**LEESBURG BOARD OF ARCHITECTURAL REVIEW  
STAFF REPORT**

**BAR Case No. TLHP-2012-0072: Replace wood windows with wood windows to match existing, trim to remain.**

**Reviewer:** Kim K. Del Rance, LEED AP  
**Address:** 109 Liberty St NW  
**Zoning:** B-1, H-1 Overlay District  
**Applicant:** Drew Lauten, Lauten Construction  
**Owner:** Stephanie Jones-Carlson

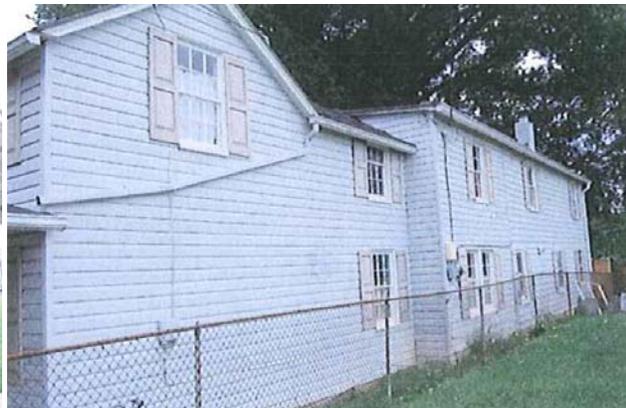
This 1875 wood frame vernacular house has original wood windows and German wood siding beneath aluminum siding that was installed prior the 1975 survey.

**Context:** This house is reflective of the styles built during the second period of growth in Leesburg from 1830 to 1878. The original house has a standing seam metal roof and original scroll sawn exposed rafter tails. Deterioration was a listed threat to the good condition of the house in the 1975 survey.

After site visit at September 17, 2012 meeting, applicant agreed to consider restoring some windows and replacing others of the total of 17 wood divided lite windows and to restore the front door, but replace 2 wood side doors (one of which is a replacement door) with wood doors to match the existing. While cost cannot be a primary consideration, the sheer volume of windows to be replaced or restored and the fact that the lead paint is a hazard when the windows are in operation, many of which are now painted or nailed shut, brings livability and therefore some aspects of affordable repairs or replacement into the discussion.

- The front door and all three (3) front façade windows, the two (2) front gable windows and all fixed windows shall not be replaced, but the treatment (abatement or restoration) of the windows shall be left to the owner's discretion as long as one window is made operable for a child in an emergency situation in the room planned to be children's bedrooms.
